Project: DEL22-025

Re: Flood Impact Assessment
Kettle Creek Golf and Country Club
320 Carlow Road, Port Stanley, Central Elgin, Ontario

Development Engineering (London) Limited (DevEng), on behalf of G-Lover Holdings Inc., is providing this letter to address the flood impact on the proposed residential development at 320 Carlow Road, Port Stanley.

CLIMATE CHANGE INUNDATION LIMITS

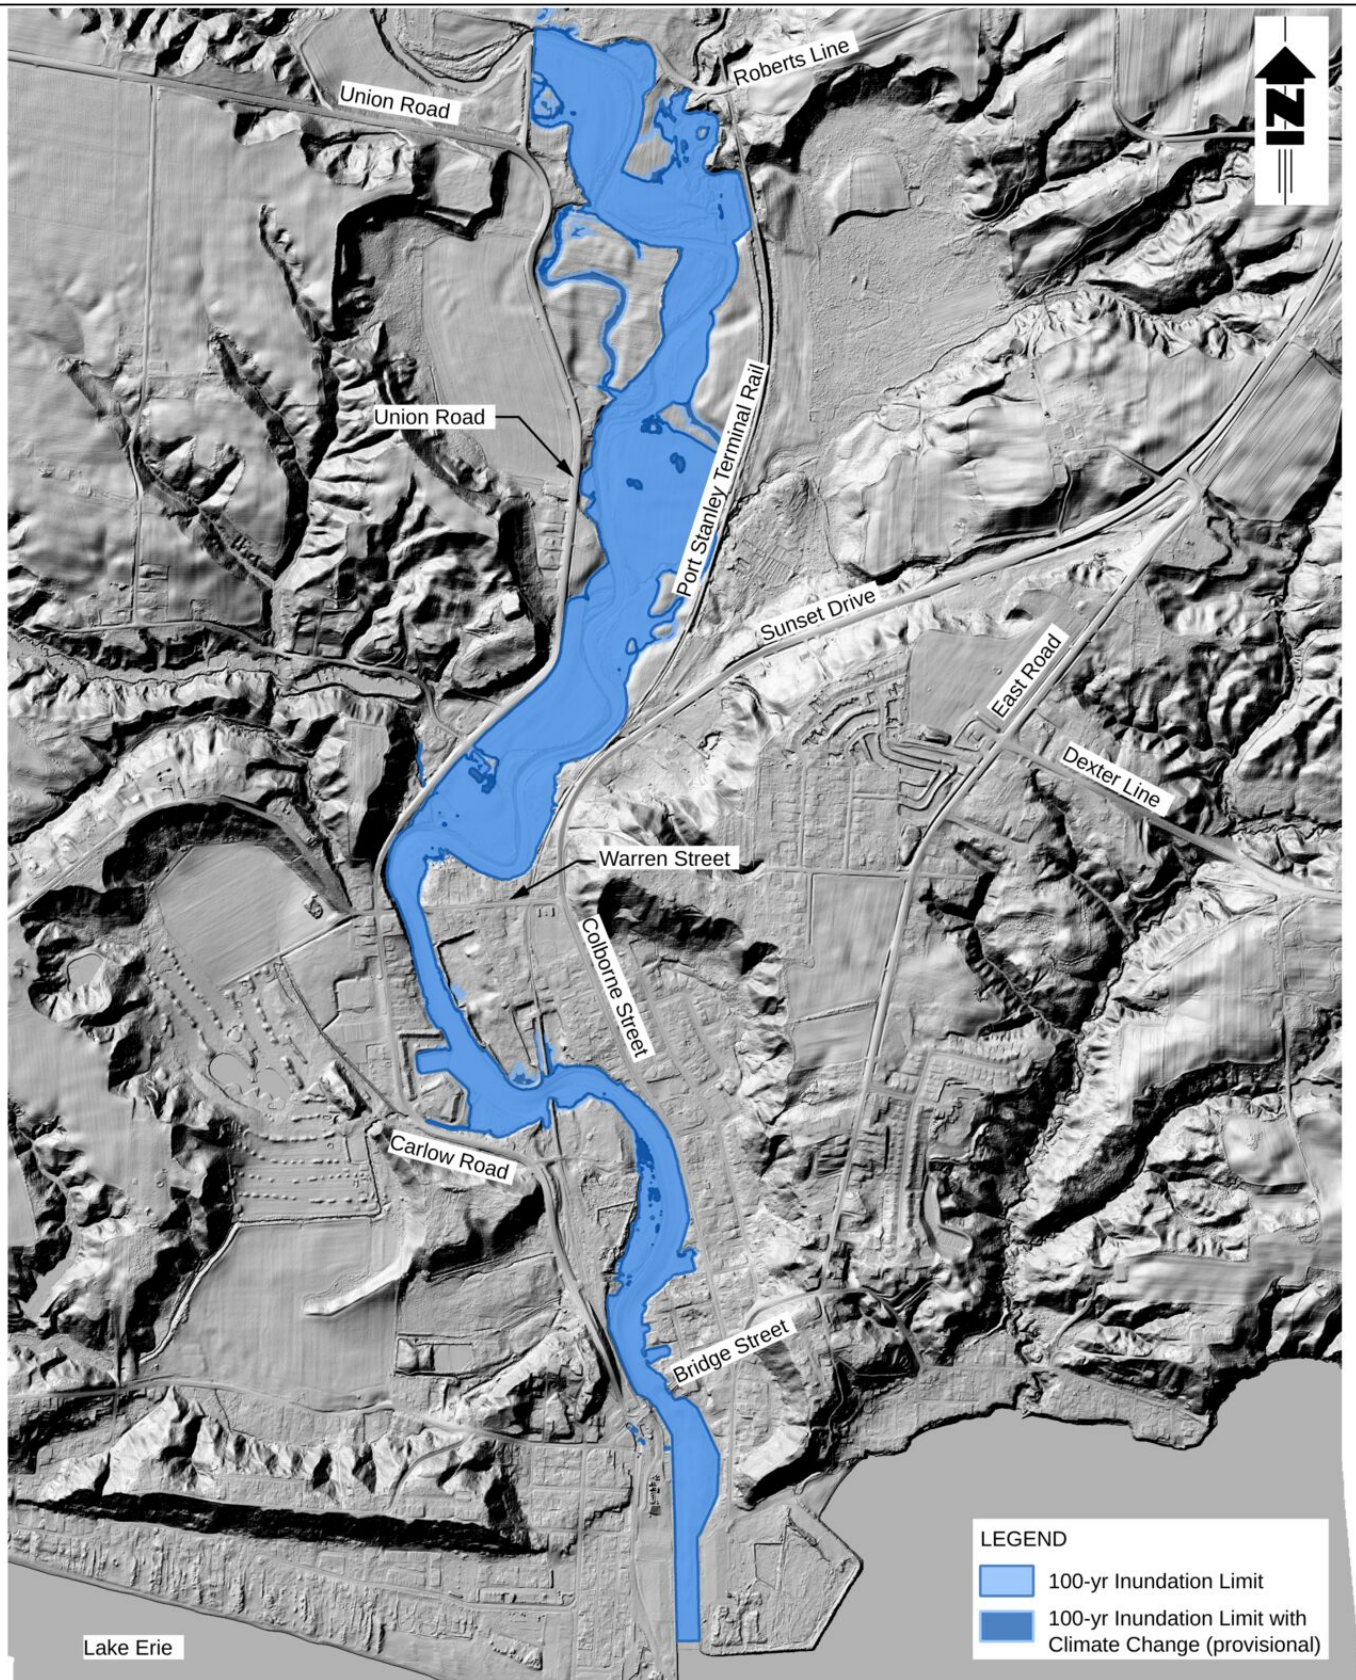
The Kettle Creek Floodplain Mapping Update by TRUE Consulting presents the inundation limits of the regional storm in Figure 6 of the report. In addition, through communications with KCCA in October 2024, it is understood that the “updated regulatory flood elevation for the area of the subject lands is 178.90 m (CVGD2013)”.

As shown on Figure 6 by TRUE Consulting, a portion of the subject development is located within the inundation limits. Within these limits is an open municipal drain known as the Marr Drain. Currently the Marr Drain conveys the subject site's stormwater runoff and is proposed to undergo maintenance as part of the *Kettle Creek Subdivision's* work. Updated drain grading will be included in the maintenance, which results in updated floodplain limits, as shown on the grading plan for Marr Drain by SBM Ltd.

PRE-DEVELOPMENT
STORAGE
41,471m³

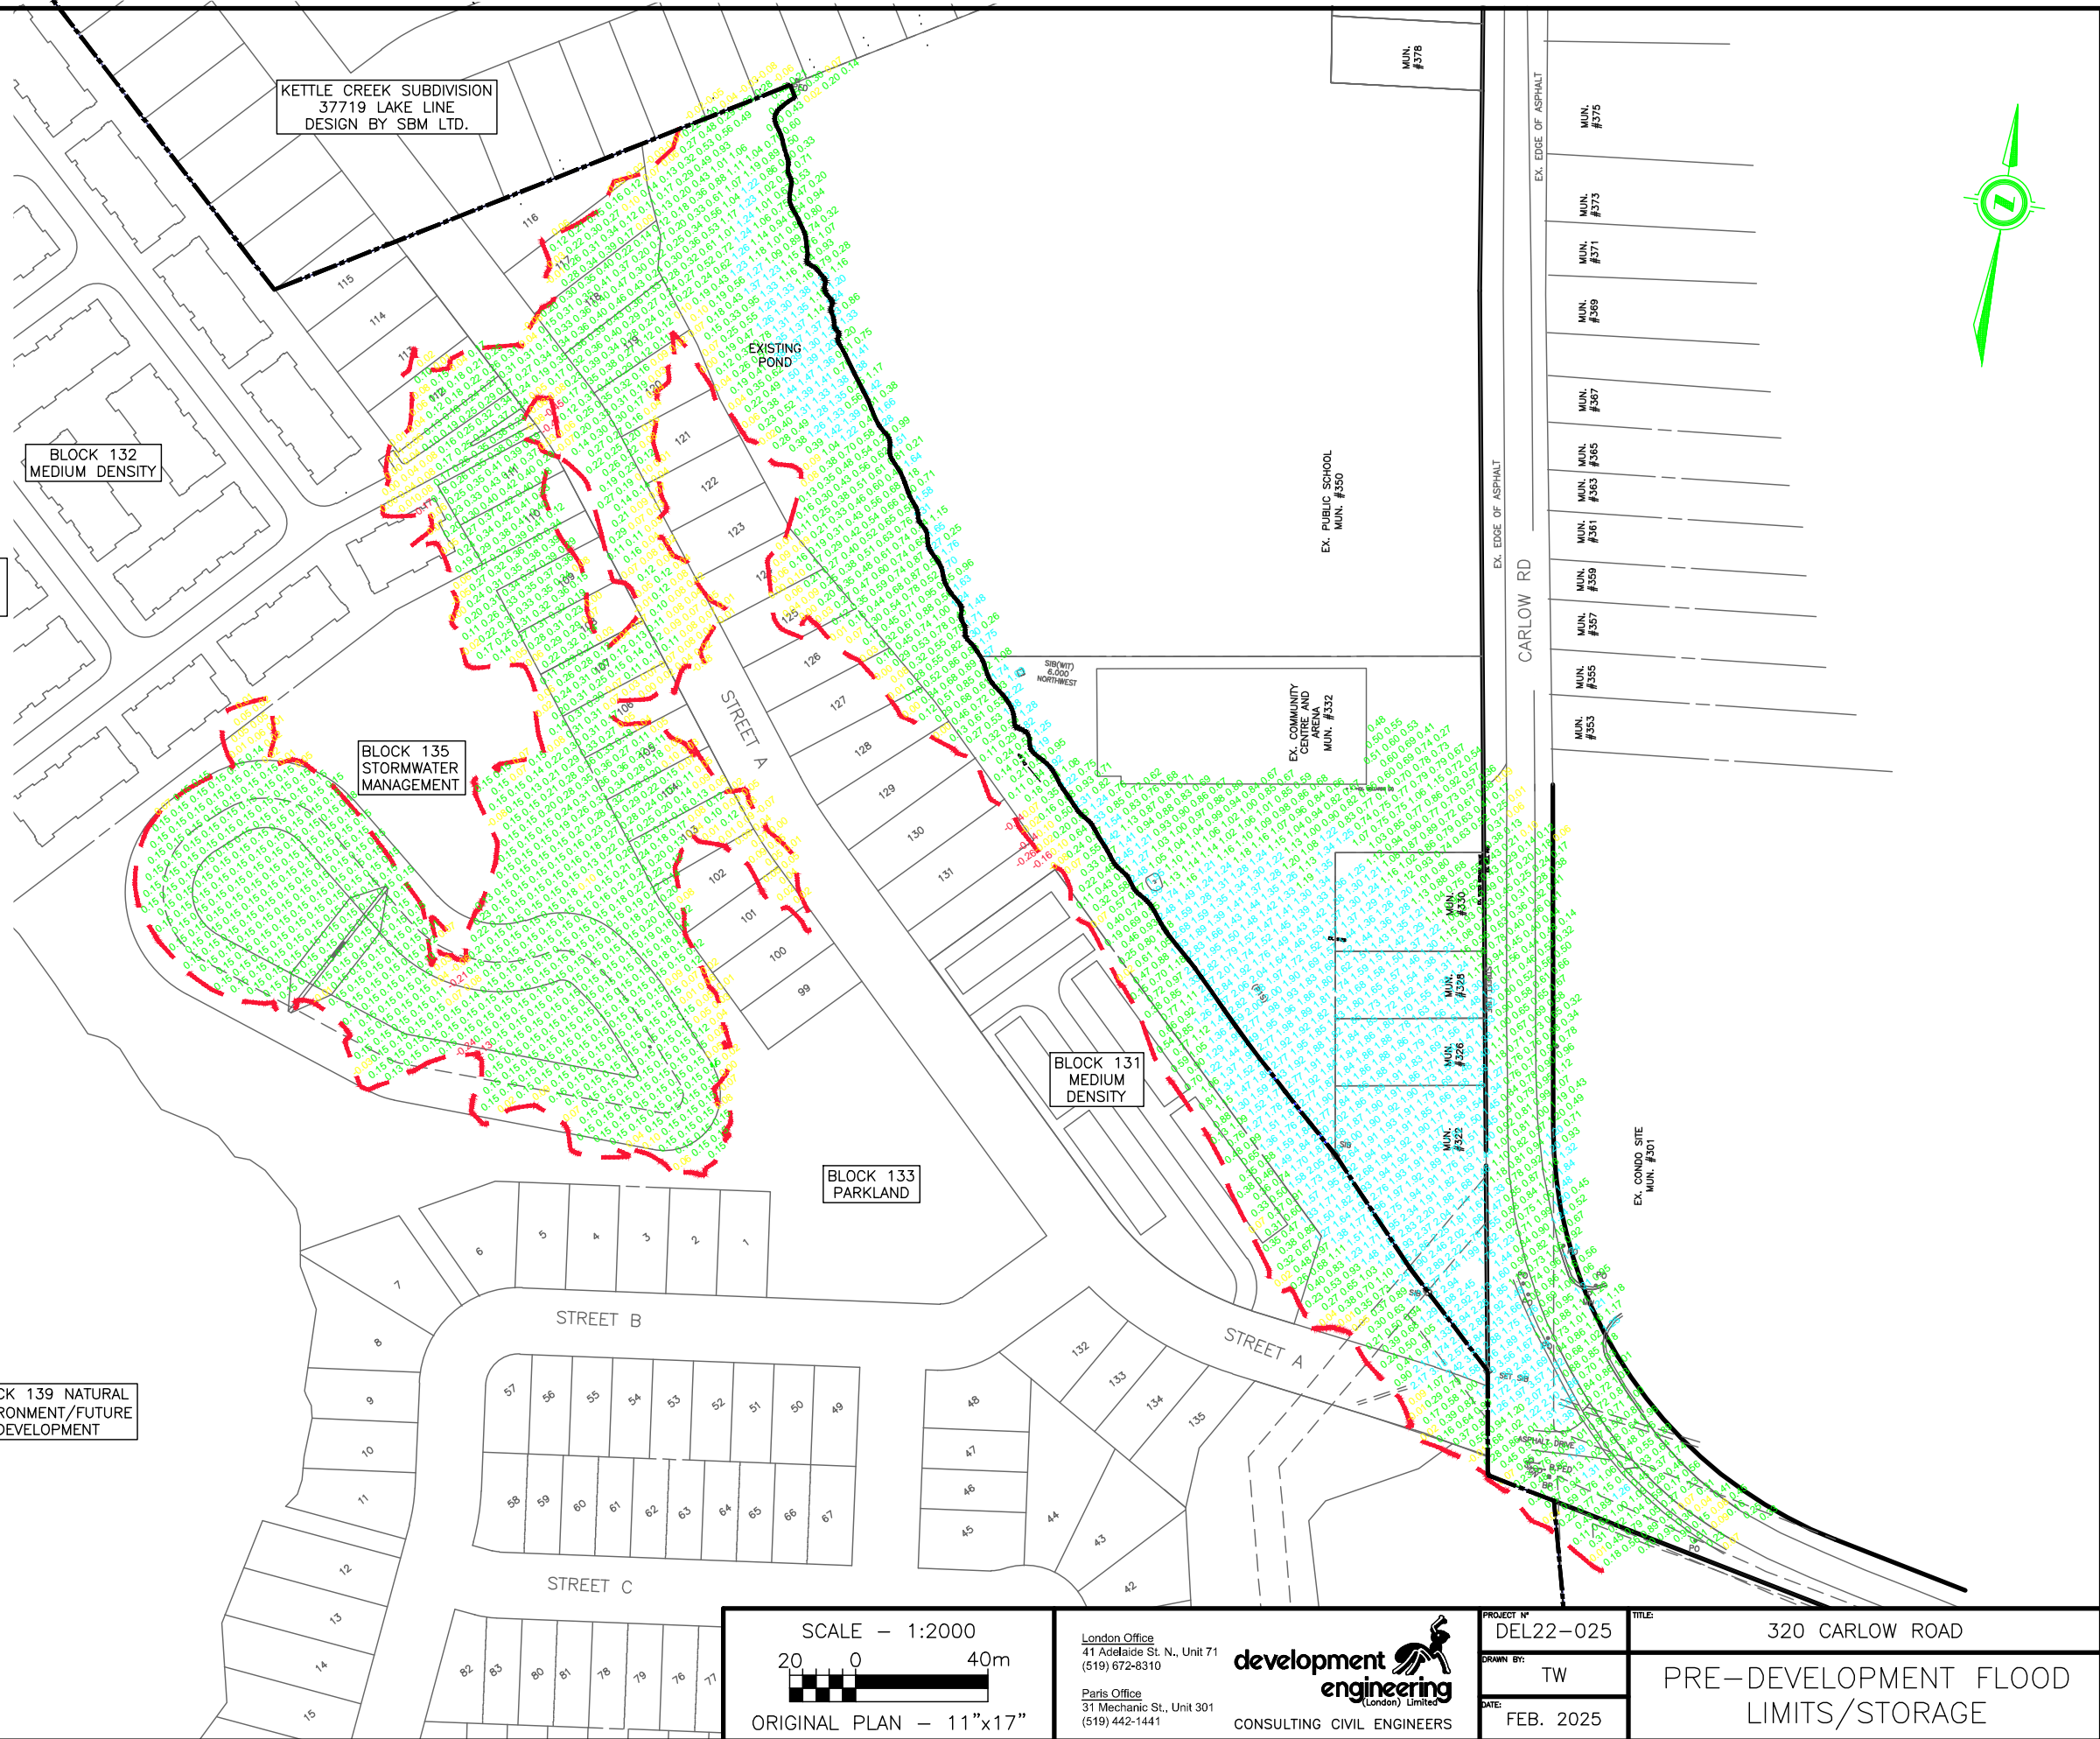
A comparison of the existing and proposed floodplain limits are identified on the aerial figure (Existing & Proposed Floodplain Limits). Although the updated floodplain limit is proposed to be reduced and located within the existing floodplain limits, an analysis to ensure floodplain storage compensation has been completed and Table 1 below summarizes the storage comparison.

<i>Floodplain Storage (m³)</i>	<i>Existing Conditions⁽¹⁾</i>	<i>Proposed Conditions⁽²⁾</i>	<i>Total Net Storage</i>
360 Carlow Road	41,471	43,927	+2,456
37719 Lake Line	1,378	8	-1,370
Totals	42,849	43,935	+1,086
